# SERVICE BULLETIN

## ONE-TIME INSPECTION OF FUEL CELL CORD ROUTING

900P3661120-101 Category A fuel cell.

### Service Bulletin SB900-114, Inspection of Fuel Cell Cord Routing.

**Figure 1. Routing of Cord 1.**

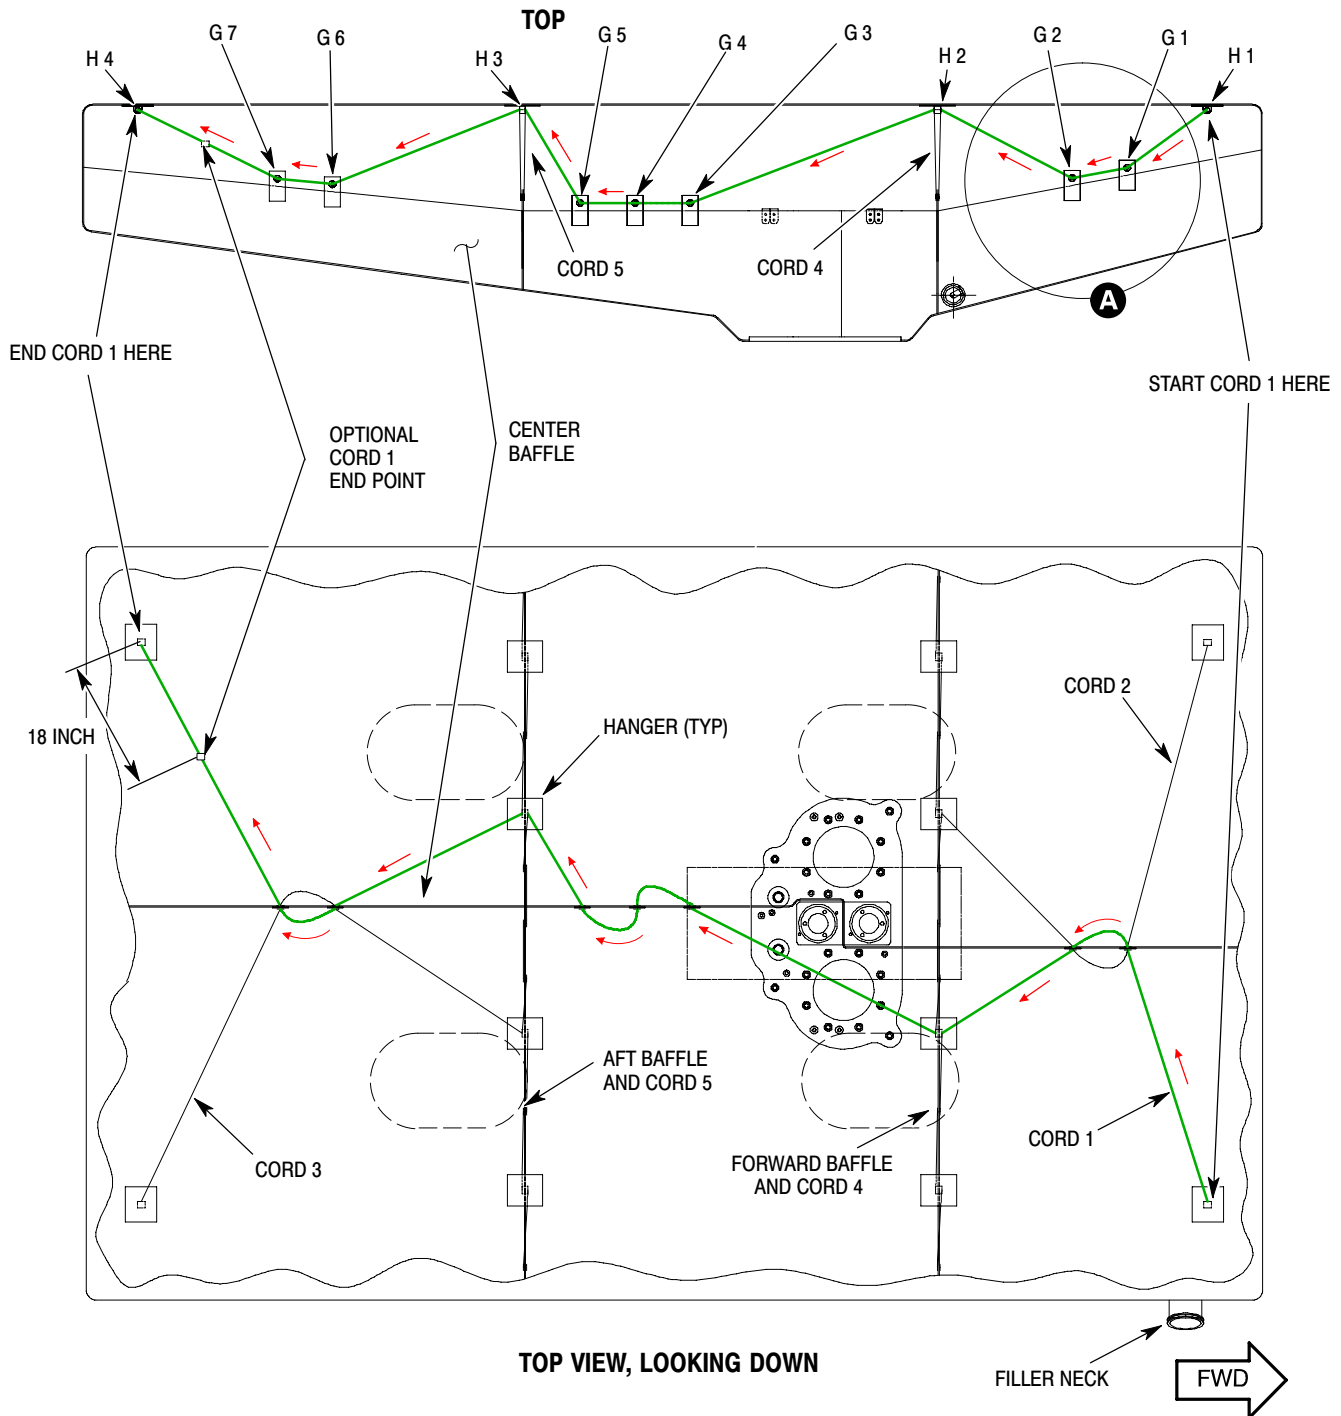
The specified range of serial numbers of Category A fuel cells may have an incorrectly routed baffle support lacing cord. If the routing of the lacing cord is incorrect, the cord can rub against the aft fuel gaging probe. If the operator does not do this bulletin, wear damage to the outer tube of the aft fuel gaging probe or the cord can occur.

- (1). Remove fuel cell access covers (refer to CSP-900RMM-2, Section 28-00-00, Fuel Cell Access Cover Removal).
- (2). Inspect Cord 1 routing (refer to Figure 1).
  - (a). If cord routing is not correct, go to Procedure C.
  - (b). If cord routing is correct, go to Procedure D.

- (1). Remove cord.
- (2). Inspect cord for wear damage.
  - (a). If there is wear damage, replace the cord with new cord (C803).
  - (b). If there is no wear damage, use the cord again.
- (3). Put a straightedge across fuel cell cavity from the left keel beam flange to the right keel beam flange.
- (4). Support fuel cell access cover fittings so that they are **1.5 to 1.7 inches (38 to 43 mm)** below the bottom of the straightedge.
- (5). Tie a bowline knot at end of cord to prevent movement through Hanger 1 (H1) (refer to Figure 2).

- (6). Thread cord through grommets 1 (G1) and 2 (G2) grommets of baffle.
- (7). Fasten cord to Grommet 2 with a half-hitch knot.

- (8). Thread cord through Hanger 2 (H2) at top of fuel cell.
- (9). Thread cord through grommets 3 (G3), 4 (G4), and 5 (G5) of baffle.
- (10). Fasten cord to Grommet 5 with a half-hitch knot.

- (11). Thread cord through Hanger 3 (H3) at top of fuel cell.
- (12). Thread cord through Grommet 6 (G6) of baffle.
- (13). Fasten cord to Grommet 6 with a half-hitch knot.
- (14). Thread cord through Grommet 7 (G7) of baffle.
- (15). Thread cord through Hanger 4 (H4) at top of fuel cell.

Figure 2. Types of Knots and Tension Check.

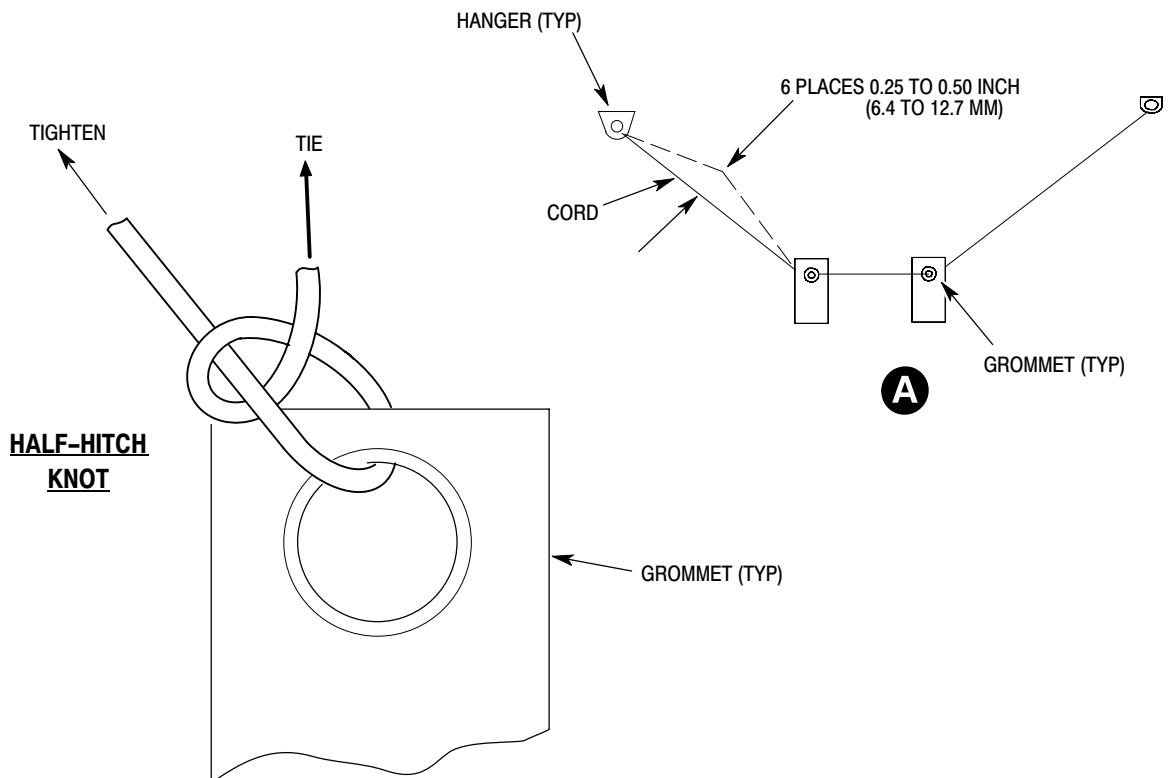
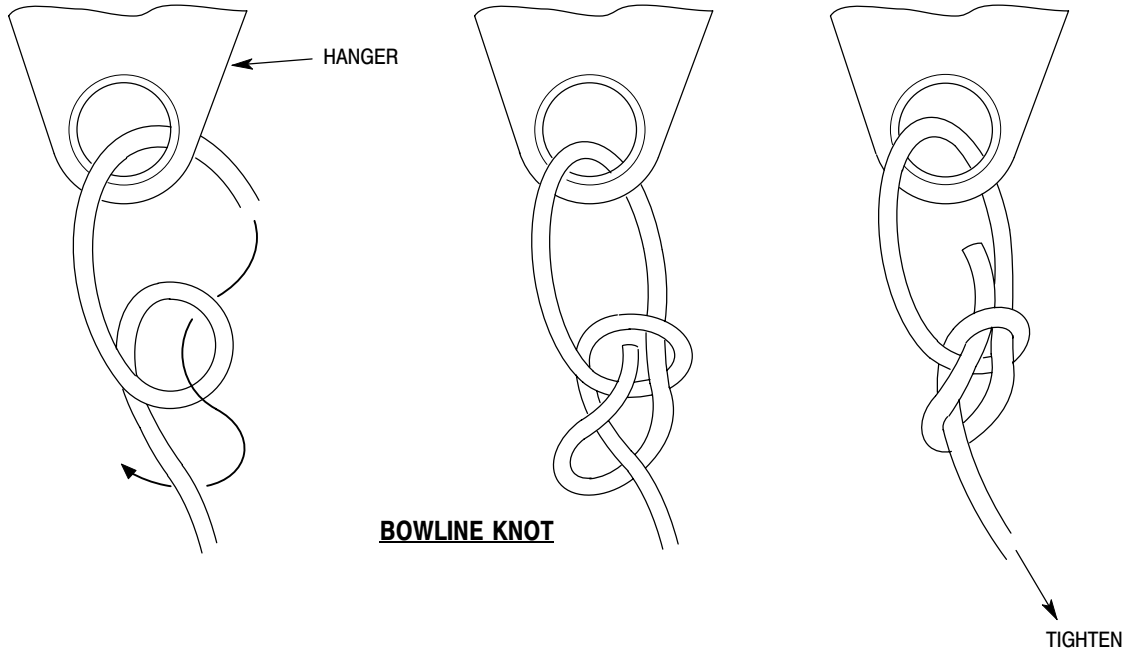
- (17). Check tension of cords between grommets and internal hangers (six places). Refer to Figure 2.
- The cord cannot move more than **0.25 to 0.50 inch (6.4 to 12.7 mm)** as measured perpendicular to lacing.

- If cord is too loose (moves more than **0.50 inch (12.7 mm)**), untie and retie cord knot(s) again to increase tension or replace cord.
  - If cord is too tight (moves less than **0.25 inch (6.4 mm)**), untie and retie cord knot(s) again to decrease tension or replace cord.
